PROJECT: Sumter Shaw Park Phase 2 ITB#36 24/255

PROJECT #: 754B

ADDENDUM NO. 1 – February 7, 2025

VETERANS PARK PHASE 2
CONSTRUCTION DRAWINGS
CITY OF SUMTER, SOUTH CAROLINA
LANDSCAPE PLAN

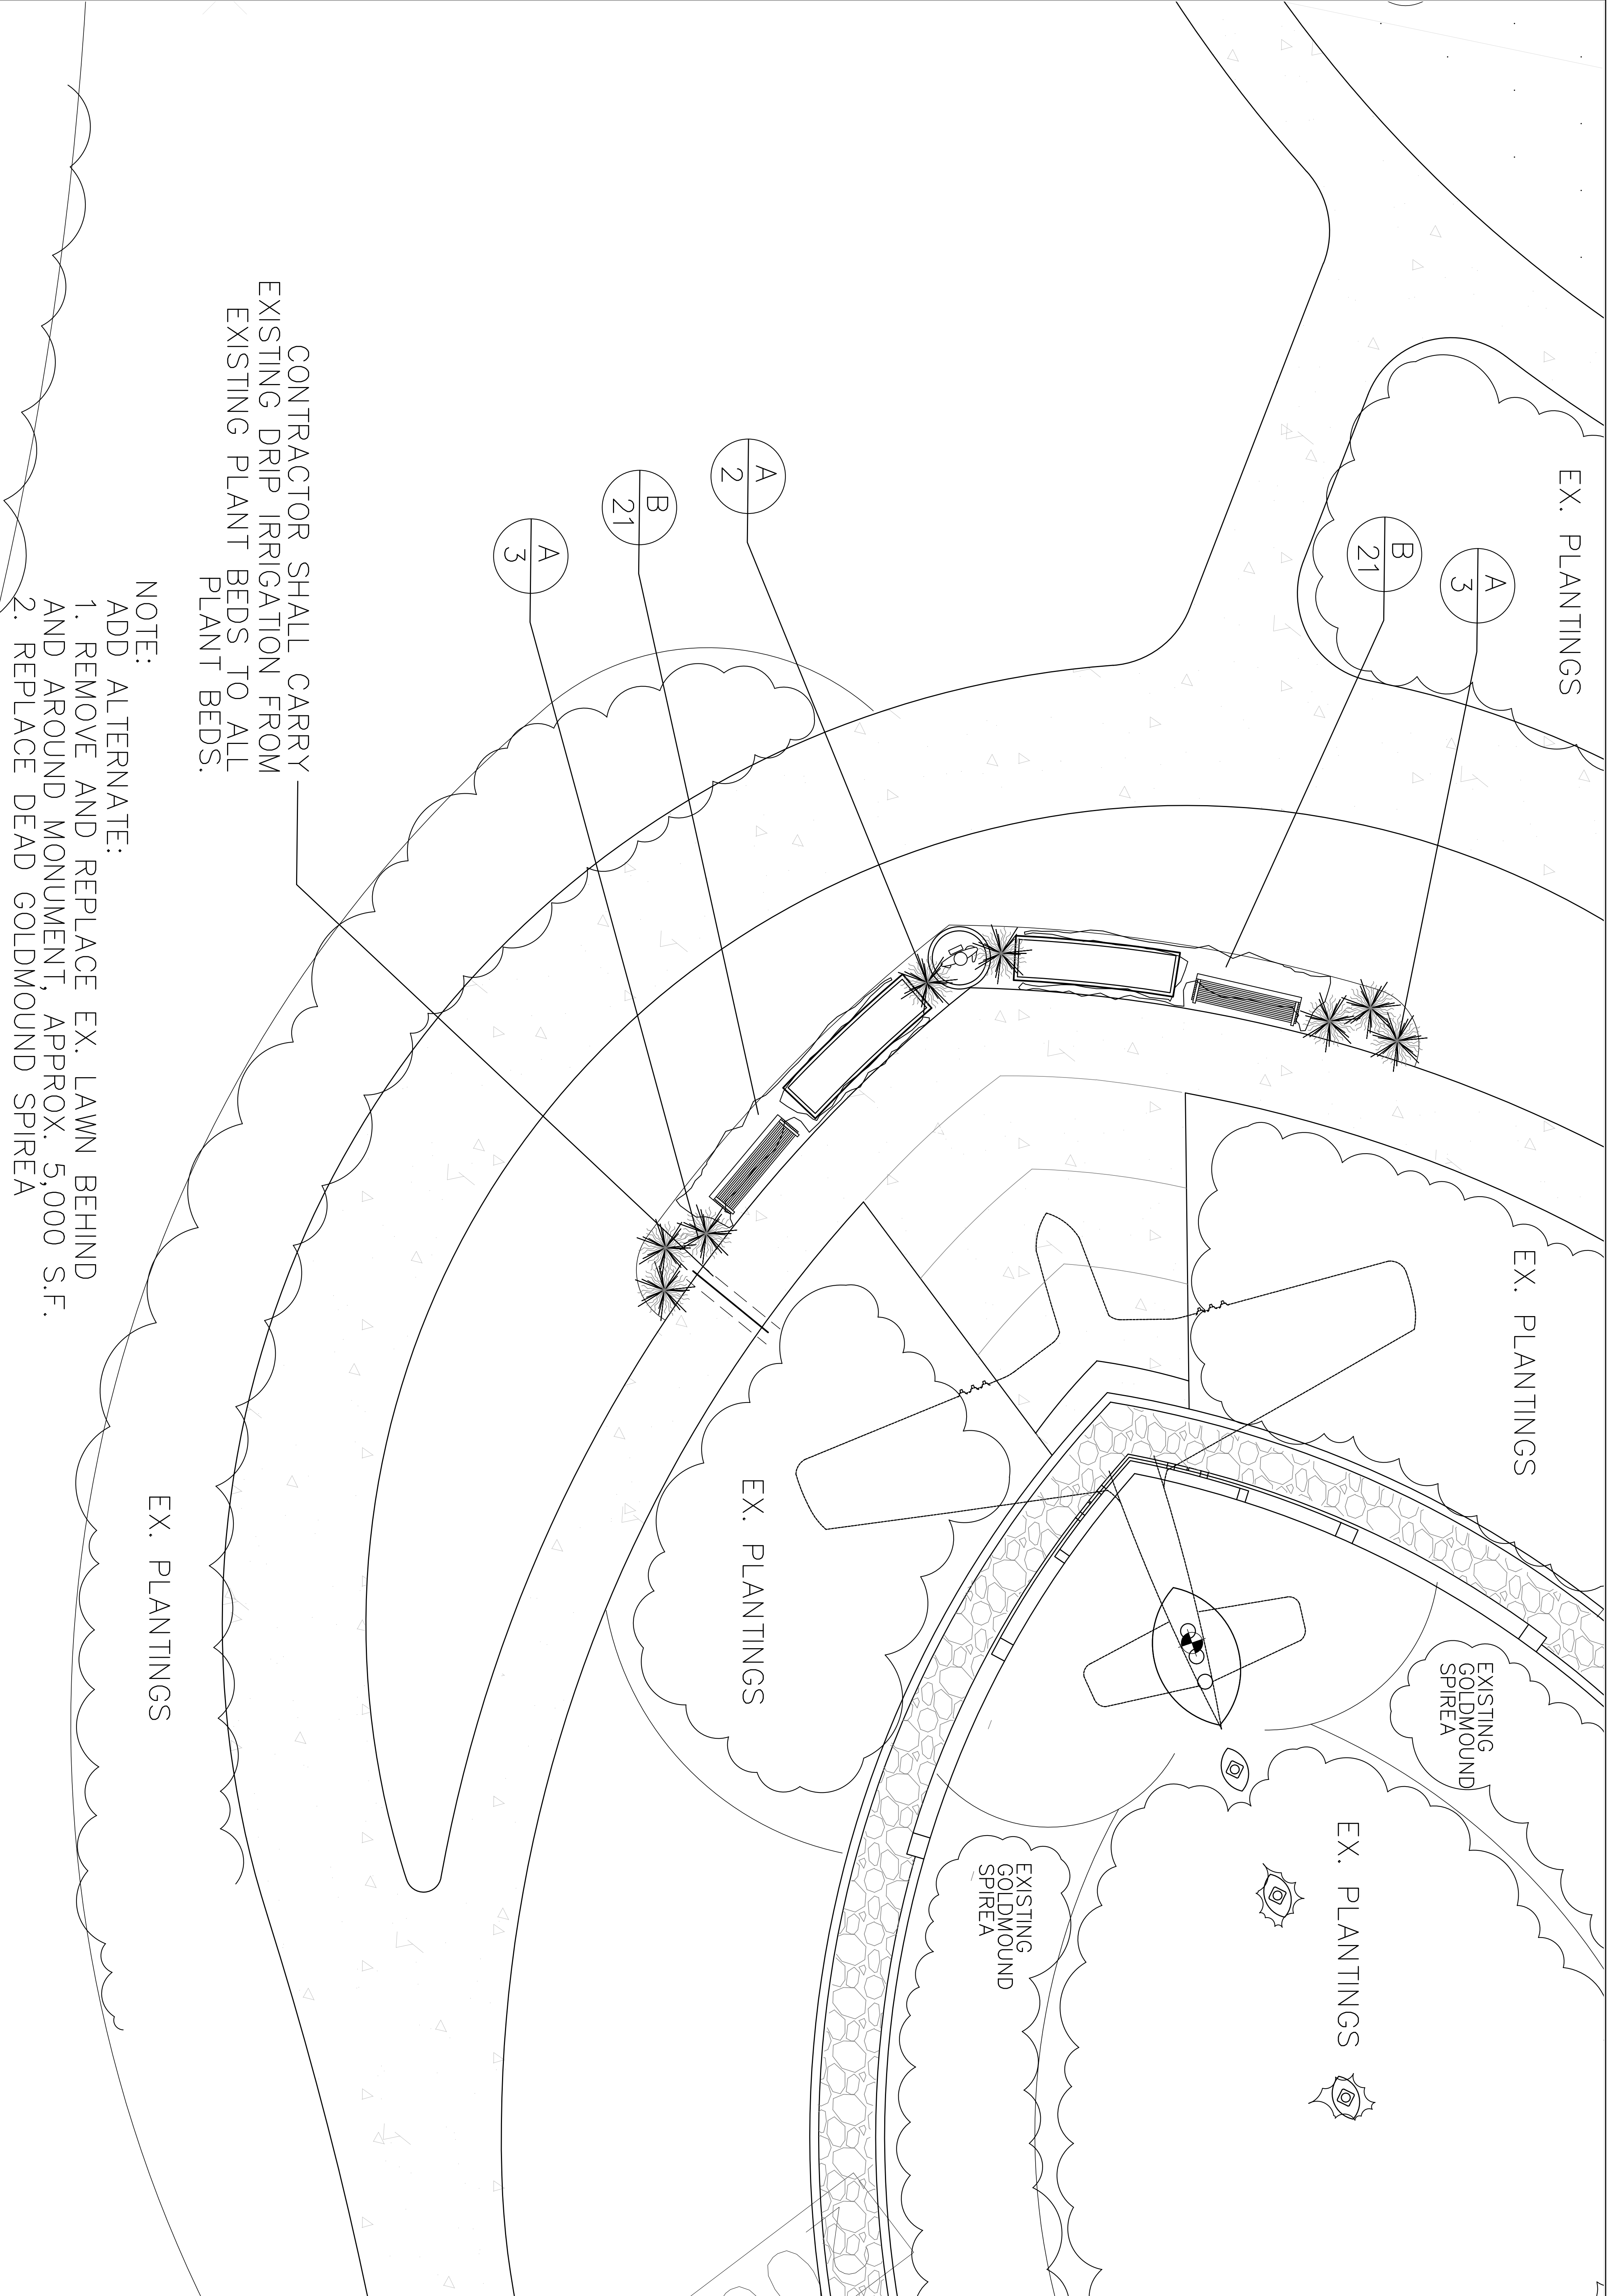
3. *Please confirm that the note on sheet 5 that states "CONTRACTOR SHALL REPLACE DEAD/DYING SOD BEHIND THE EX. AIRPLANE MONUMENT, APPROX. 6,000 S.F." is a duplicate of the note at the bottom of the same page & can be ignored.*
Yes, This is corrected on the attached Sheet 5 No.1 Addendum No 1.

Sheet 5,

Remove and replace in its entirety removing miscellaneous note regarding sod quantity.
